Docket No. 50-206
LS05-83-07-048

SUBJECT: SEP HYDROLOGY TOPICS II-3.A, II-3.B, II-3.B.1, AND II-3.C,
SAN ONOFRE NUCLEAR GENERATING STATION, UNIT 1

SYSTEMATIC EVALUATION PROGRAM

Plant Name: San Onofre Nuclear Generating Station
Docket Number: 50-206

Figure 1 Offsite and Onsite Drainage Basins

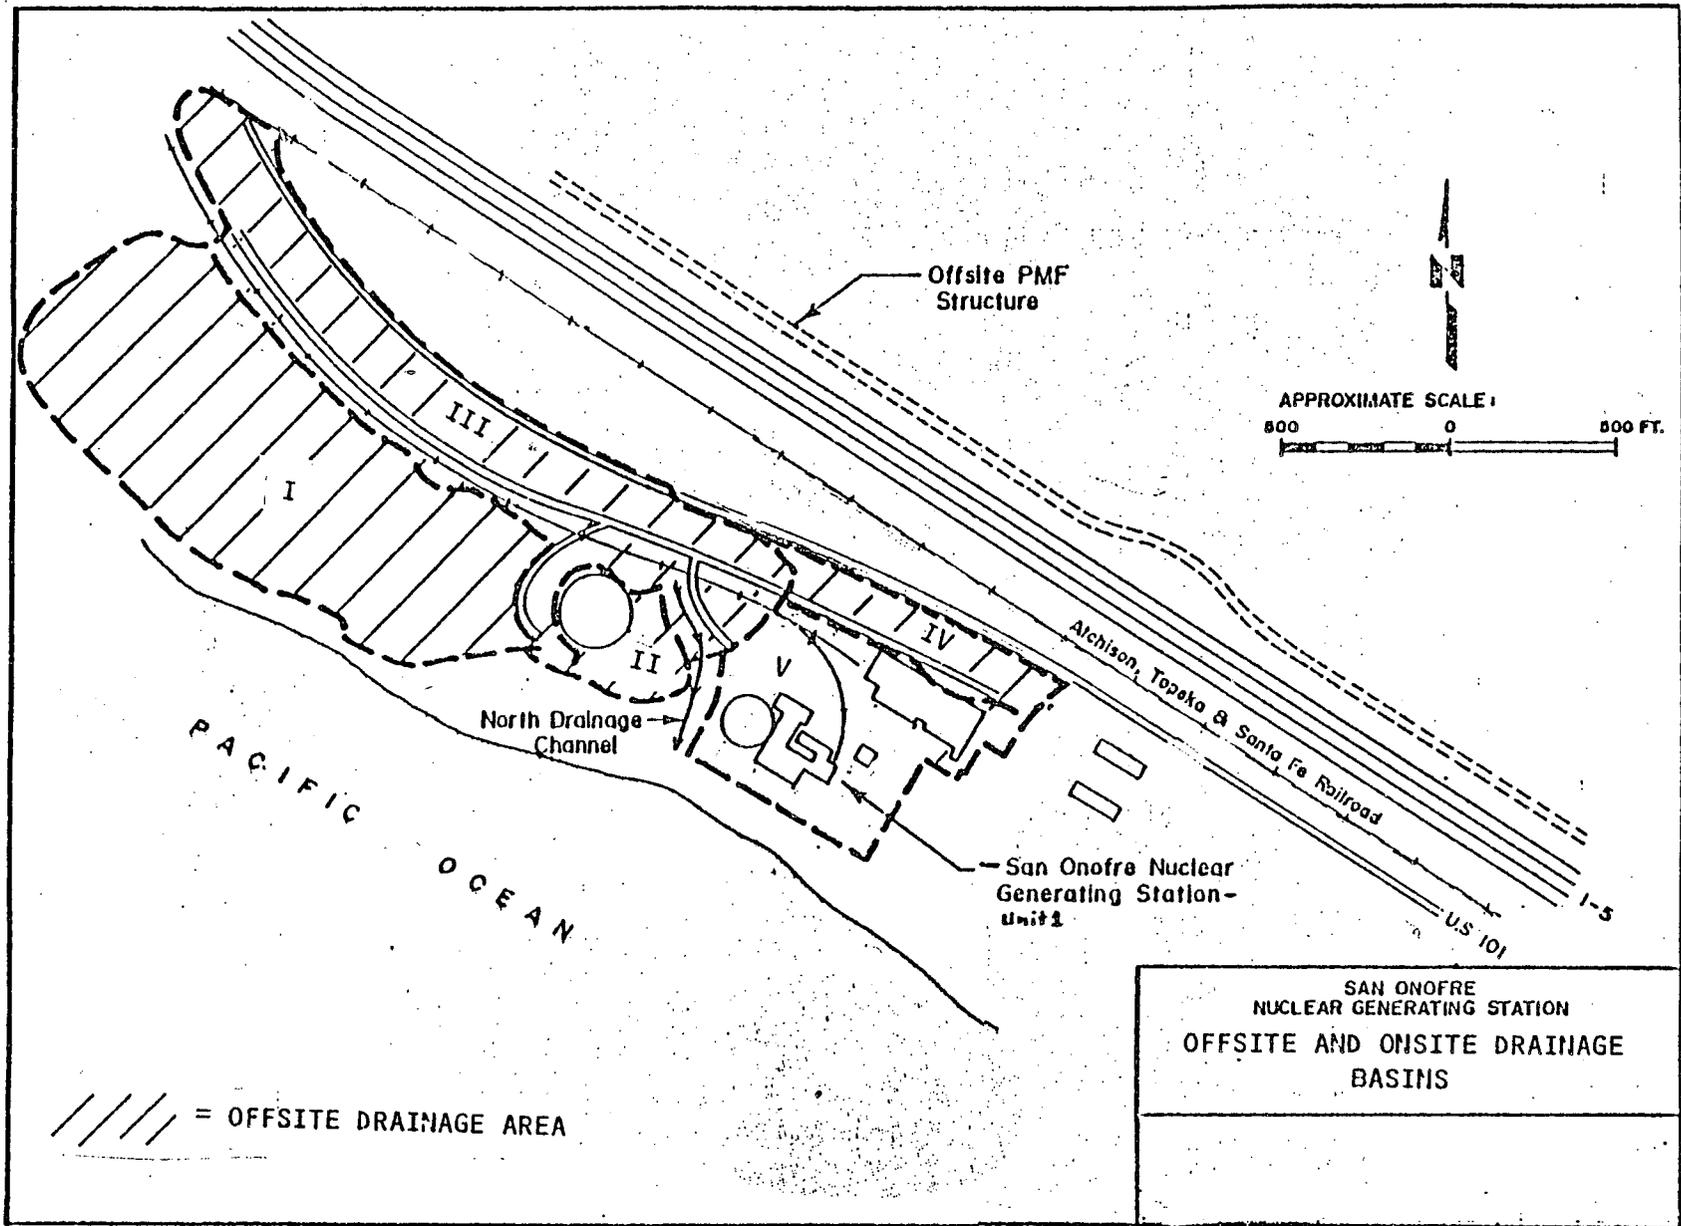
The attached TER (TER Fig. 4) shows eight drainage subbasins that were evaluated for potential effects at the site. Three of the subbasins do not contribute flow to the Unit 1 plant area. Our summary evaluation addresses the remaining five subbasins, shown as areas I thru V on Figure 1.

Subbasin V represents the confined main plant area and PMP on this area would produce a PMF with a peak discharge of about 168 cfs. The yard sump has a capacity to discharge about 190 cfs before safety equipment is affected and thus can safely handle the peak discharge from the confined plant area if there is no other contributing flow from offsite.

Subbasins I, II, III & IV represent site drainage that is outside the confined plant area. This flow is routed to the North Drainage Channel where it discharges through the sea wall and/or through two 48 inch diameter corrugated metal pipes (CMP) to the intake structure and to the Pacific Ocean. PMP on this area would produce a PMF with a peak discharge of 385 cfs. The staff recognizes that a portion of the flow from subbasins I and II will probably flow over the bluff and directly to the Pacific Ocean. However, since we did not have sufficiently detailed topographic information to evaluate the actual division in flow, it was conservatively assumed that all runoff would be through the North Drainage Channel.

The staff has some reservation with respect to discharge capability of the 30 inch and 42 inch gated outlets through the seawall and the two 48 inch CMP that divert flow to the intake structures. Basically our concerns are for possible flow reduction due to silt and debris accumulation and blockage of the flap gate on the 42 inch outlet.

Our contractor (FRC) tested two scenarios involving the degree to which the storm drain systems were clogged by debris. The lower 42 inch-diameter Reinforced Concrete Pipe (RCP) flapgate (invert elevation 10.0 ft. MLLW) at the mouth of the north drainage channel was assumed blocked by beach sand for both scenarios tested.

The first scenario assumed that all other drain systems were operating with the twin 48 inch CMP at 90% capacity and the 30 inch CMP at 40% capacity. The results of the contractor's evaluation show that the North Drainage Channel can handle a peak discharge of 336 cfs with 49 cfs overflowing the flood wall and combining with the 168 cfs from subbasin V for discharge through the yard sump and yard drainage system. The resulting water surface elevation in the confined plant area would be elevation 15.5 ft. MLLW. Hence, the contractor stated that safety related equipment would be flooded. However, our contractor did not consider available yard storage. With consideration for this storage, the flood level would be below safety related equipment.

The second scenario assumed that both the seawall culverts (30 and 42 inch) were 100% blocked and the twin 48 inch CMP's were operating at 90%

capacity; the yard drainage system is completely blocked and the yard sump operates at 100% capacity. The results of this contractor evaluation show that the North Drainage Channel can handle a peak discharge of 310 cfs and the remaining 75 cfs will overtop the wall and combine with the 168 cfs from Subbasin V to be discharged through the yard sump. This water would pond in the confined area to about elevation 23 feet MLLW. Safety related equipment would be flooded. As in the previous scenario the contractor did not take into consideration the effects of yard storage capacity on predicted flood levels. The staff has made independent evaluations in this area and we conclude that the worst case flood stage in the confined plant area would be about elevation 15.5 ft MLLW. Hence, the staff concludes that safety related equipment would be flooded for this scenario. The elevations of various safety related equipment can be found in reference 16.

C. Local Flooding - San Onofre Unit 1 does not meet current criteria for flooding from local PMP. Under conditions which can be reasonably foreseen to occur, ponding will rise to elevation 15.5 ft MLLW in the plant yard during PMP. Safety-related equipment would be flooded.
